TECHNICAL SERVICE BULLETIN

Bulletin Number: Z-16-01-AA

**SUBJECT: 2014-2016 RZR XP / XP 4 1000 and 2015-2016 RZR 900 / S 1000
FUEL TANK VENT LINE REPLACEMENT**

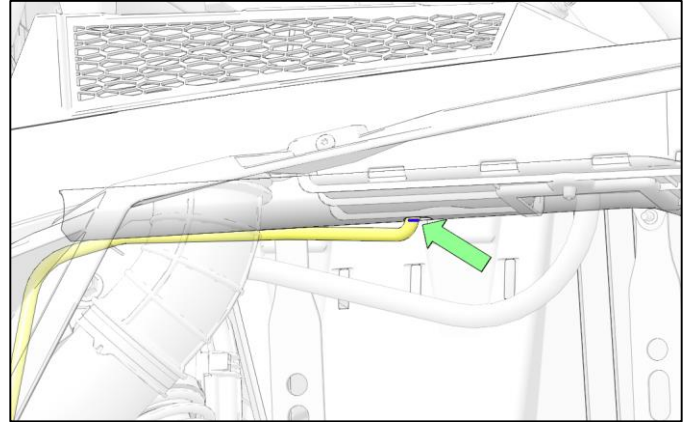
1. Loosen the fuel cap.
2. Mark the fuel tank vent line to determine original depth into frame.
 - 2014 and 2015 (early build) RZR XP 1000 / XP4 1000 – on cross member frame rail behind the airbox.
 - 2015 (late build) RZR XP 1000 / XP4 1000 – on the rear upper frame rail above the PVT

RZR XP 1000 / XP4 1000 (early build)

RZR XP 1000 / XP4 1000 (late build)

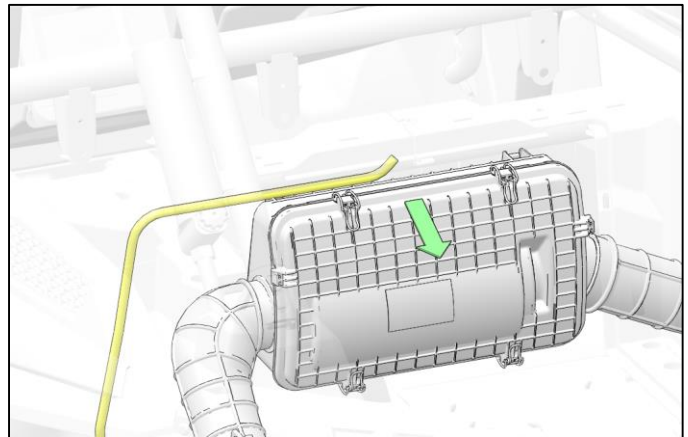
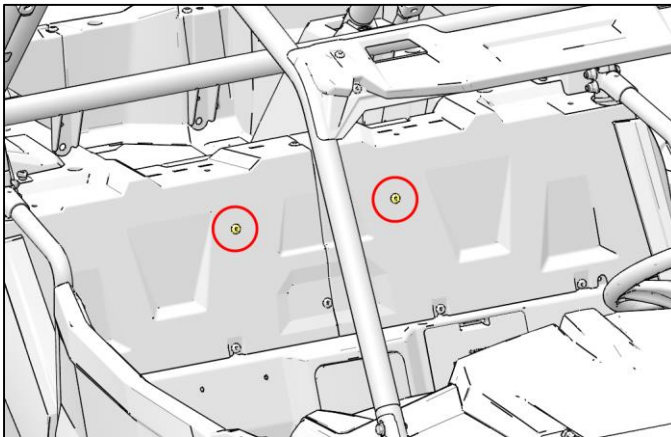
3. Remove the fuel vent line from frame.

NOTE: For 2014 and early build 2015 RZR 1000 models ONLY, remove the seats (rear seats for XP4 models) and two bolts (circled in red) retaining the upper air box and carefully pull the air box towards the rear of the vehicle for improved access to the vent line.

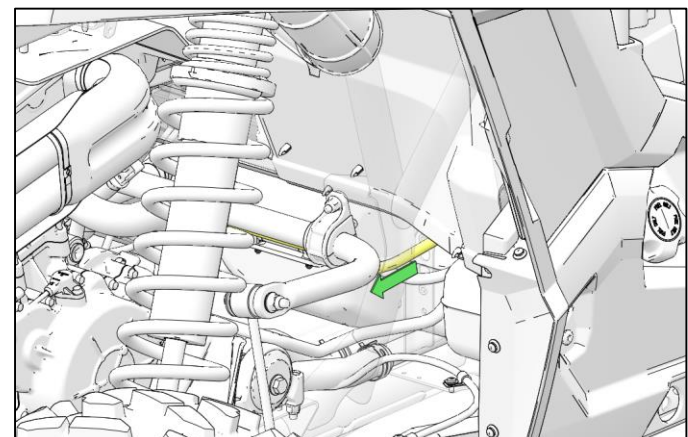
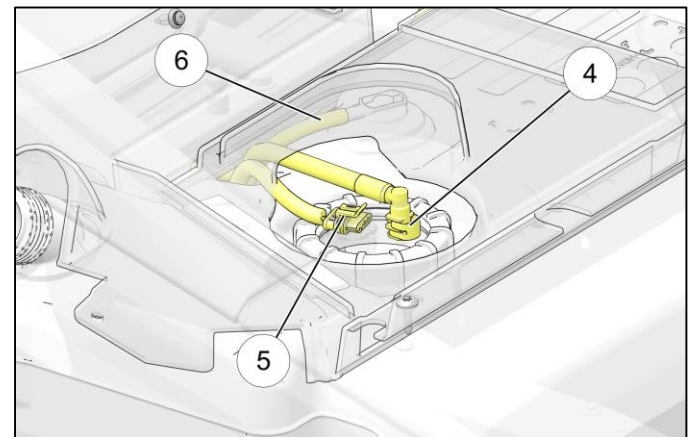
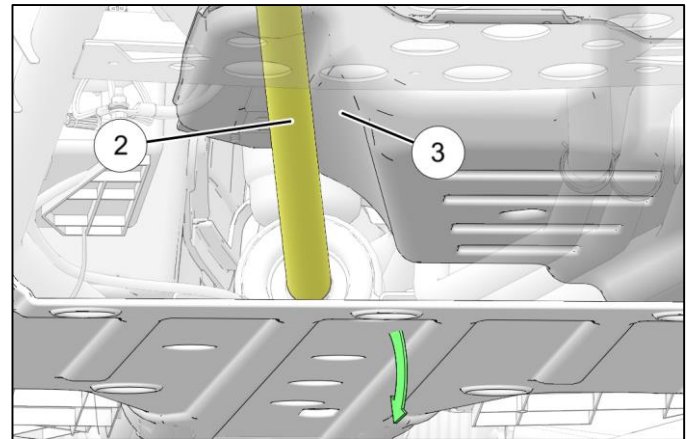
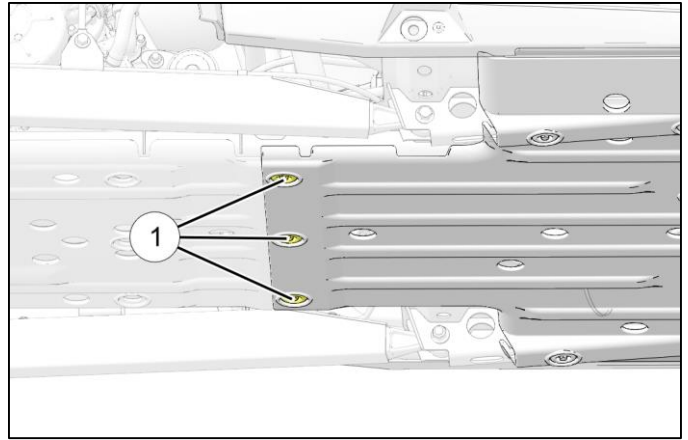
6. Remove the three rear skid plate fasteners ① to gain access to the prop shaft and fuel tank.
7. Inspect for damage due to the prop shaft ② rubbing into the fuel tank ③. *If there is damage from the prop shaft, take photos of the damaged vent line, the wear on the prop shaft, and the damage to the fuel tank. Start an Ask Polaris → Service and Warranty Question → Authorization: Non-Cosmetic & Polaris ESC case. Attach the photos to the case and for the CONCERN, CAUSE and CORRECTION enter "SB Z-16-01-AA". Use part number 2521436 as the primary failed part, enter the appropriate flat rate time, and submit the case to Polaris. You will still need to file the service bulletin claim once completed.* Continue to step 8.

8. Remove the seats for 2-seat models or the rear seats for XP4 models.
9. Disconnect the negative and positive battery cables from the battery. While holding a clean shop towel over the fuel line fitting, disconnect the fuel supply hose ④ and the fuel pump harness ⑤ from the fuel pump assembly.

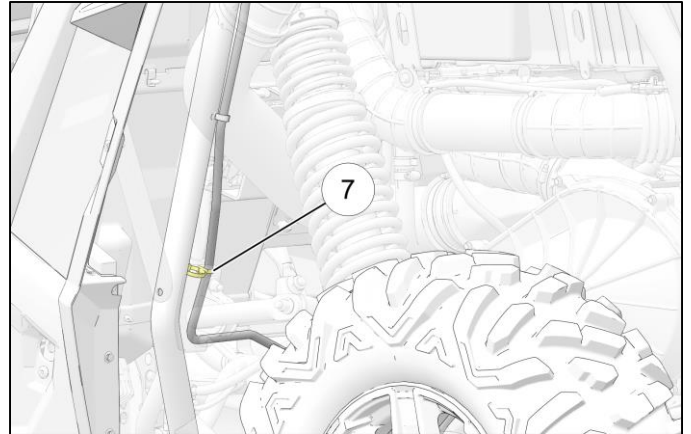
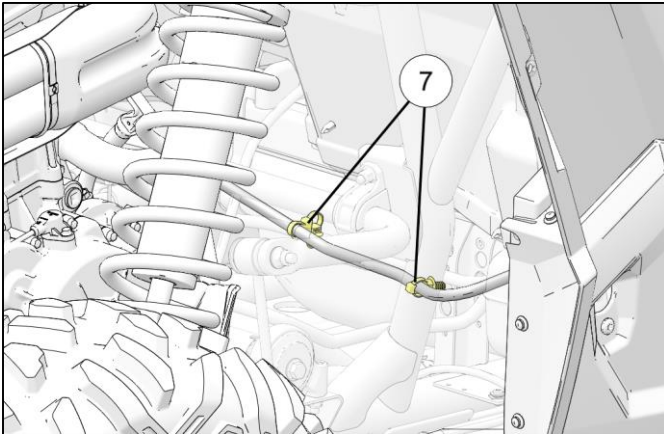
10. Reach under the fuel tank close off panel and disconnect the fuel tank vent line ⑥ from the tank breather fitting.
11. Remove the original fuel tank vent line by pulling the line out by the rear stabilizer bar mount.
12. Slide the new vent line through the opening for the fuel pump so the hose comes out near the rear stabilizer bar.

13. Slide the original vent line out of the zip ties (7) retaining the vent line and slide the new line through the zip ties.

NOTE: The vent hose fits loosely in the zip ties so they shouldn't need to be cut.

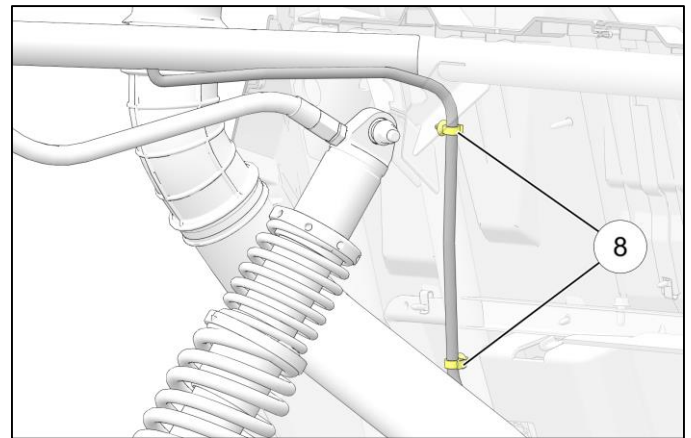
14. Open the line clips (8), located on the frame upright for the driver's side rear shock, and remove the vent line and install the new vent line and refasten the clips.

15. Using the original vent line routing as a guide, route the new vent line through the upper shock mount area. Use caution to avoid kinking the vent line during installation.

16. Install the new vent line onto the fuel tank fitting.

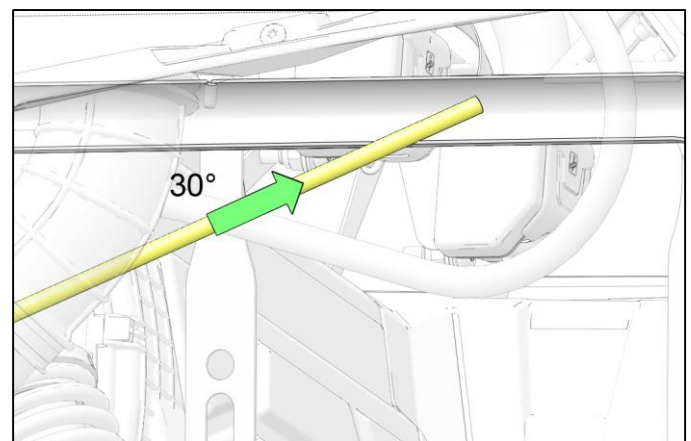
18. Using the old vent line as a reference, put a mark on the new vent line to indicate the depth the hose should go into the frame.

19. Attach a Mityvac to the end of the new vent line. Apply vacuum (approx. 5 pumps). The Mityvac should not build any vacuum in the fuel vent line (when applying vacuum, you can hear valve in tank cycling if vent line is not restricted). If vacuum is built, inspect the vent line for kinks. If no vacuum is built, **use engine oil or penetrating oil to lightly coat the outside surface of the vent line up to the mark of the original depth.** Insert the vent line into the frame tube starting at an angle less than 30° from parallel to the frame tube as shown..

IMPORTANT: Inserting at this angle (or less) is critical to avoid risk of kinking the vent line during installation. Always apply engine oil or penetrating oil to the hose. Insert the hose to a depth slightly past the original mark.

20. Pull line back out slightly to ensure it's not kinked, and reinsert to original depth mark.
